Peach Bottom Atomic Power Station Unit Nos. 2 and 3
Facility Operating License Nos. DPR-44 and DPR-56
NRC Docket Nos. 50-277 and 50-278

Subject : Addendum to Radiation Dose Assessment Report No.23, January 1,2007
 through December 31, 2007

**Addendum to Radiation Dose Assessment
Report No. 23**

Figure B-3
 Environmental Sampling Locations Greater Than
 Five Miles from the Peach Bottom Atomic Power Station, 2007

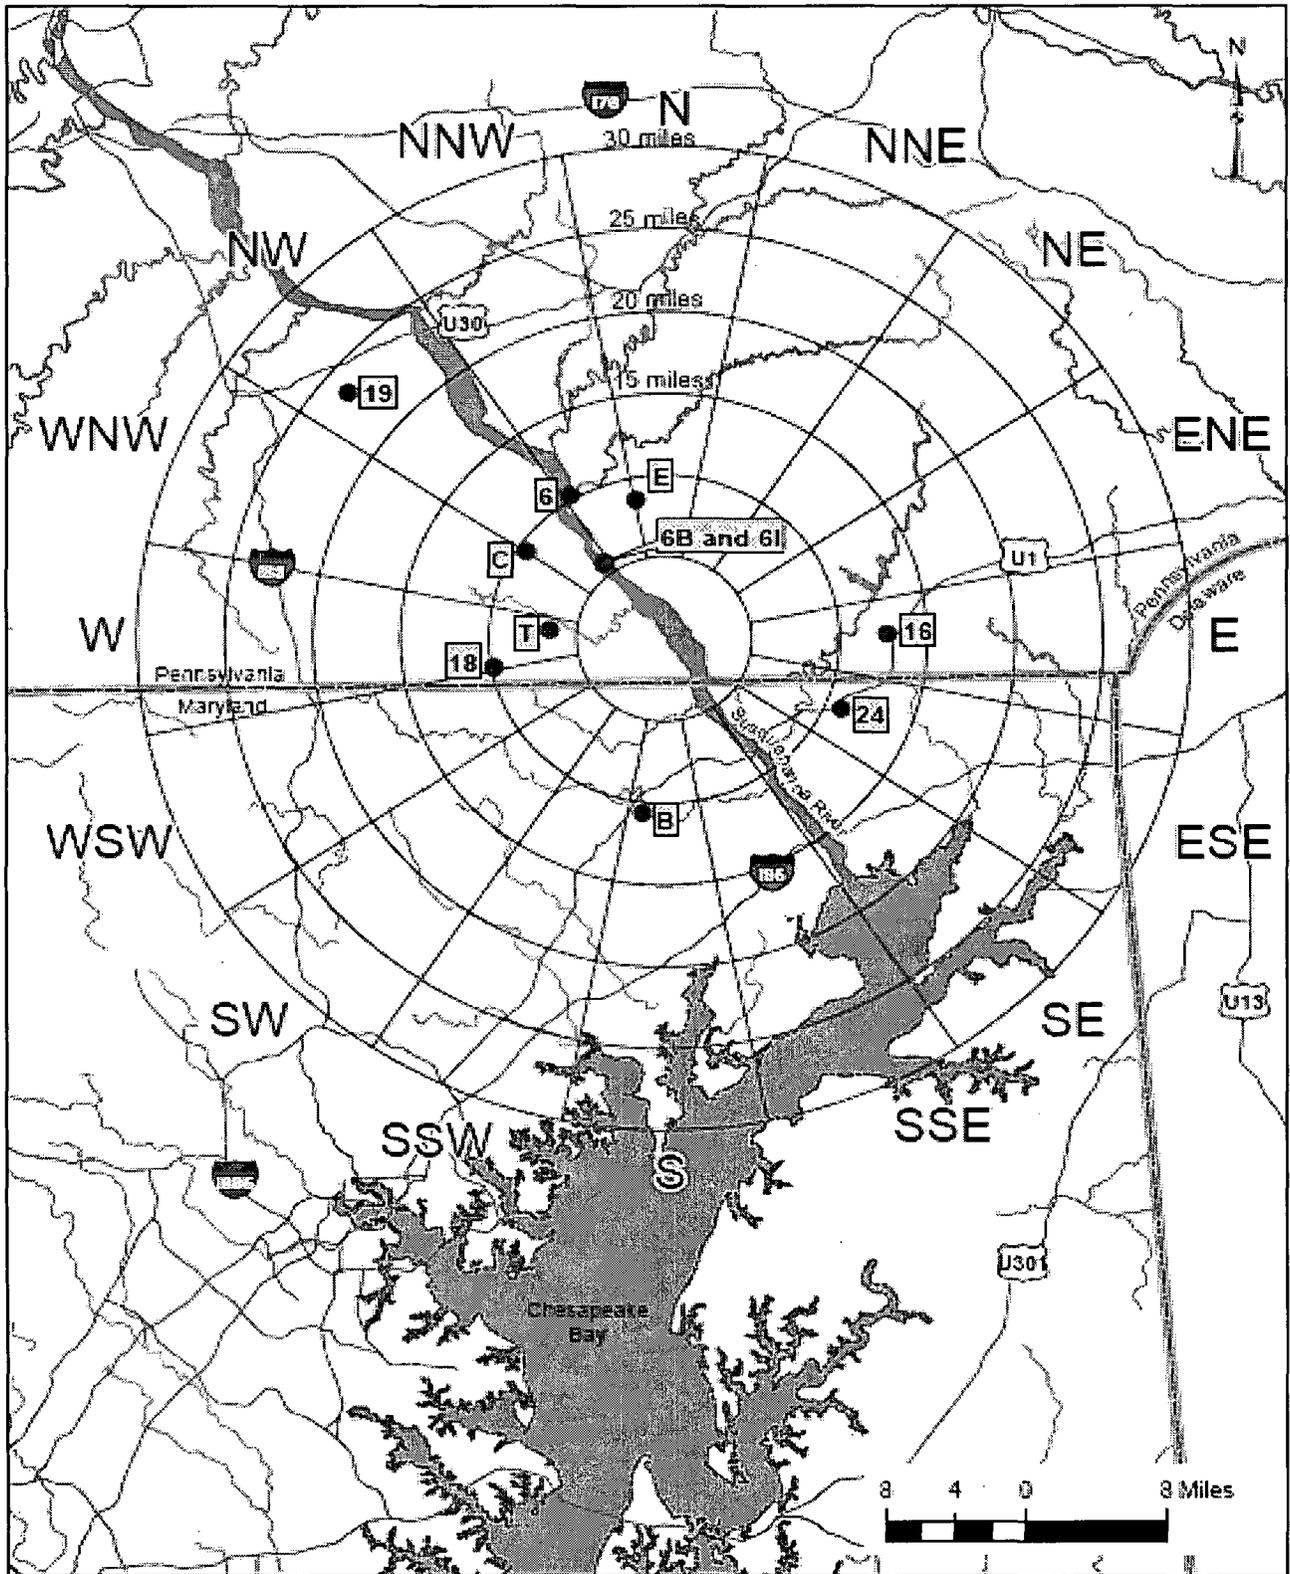
Please see attached Addendum to the Radiation Dose Assessment Report No.23.
FIGURE VII.A.3 "Environmental Sampling Locations Greater Than
Five Miles from the Peach Bottom Atomic Power Station, 2007" was corrected to
indicate Farm T being located in the W sector versus the WSW sector in the original
submittal
